Draft Yarra Planning Scheme Amendment C307yara and
Draft Planning Permit PA2201662
Referral 35: Victoria Gardens Expansion

Priority Projects Standing Advisory Committee Report

21 December 2023

Figure 6 Example of Doonside Precinct development interface with car park boundary⁵⁴

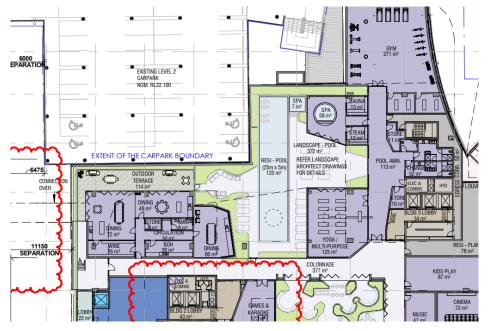
- was concerned about the Level 1 interfaces of the Doonside Precinct development with the existing multi-level carpark to the Centre
- considered the relationship between the car park and the proposed external common areas would be problematic, with excessive overshadowing and an unattractive boundary condition
- suggested the southern section of the car park could demolished and replaced with commercial space.

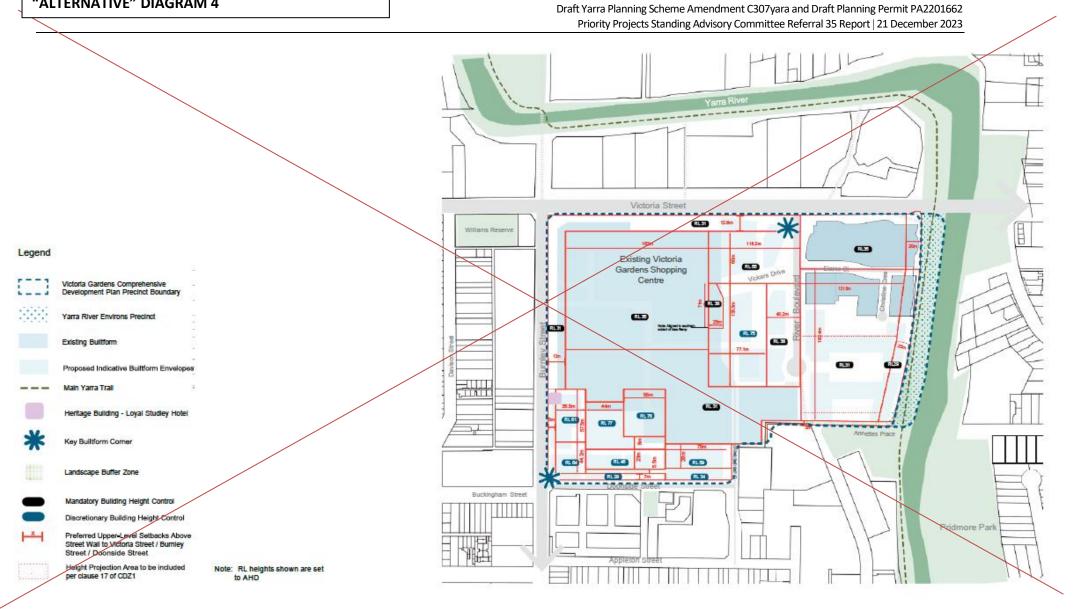
DELETE DIAGRAM 4 AND REPLACE WITH "ALTERNATIVE" DIAGRAM 4
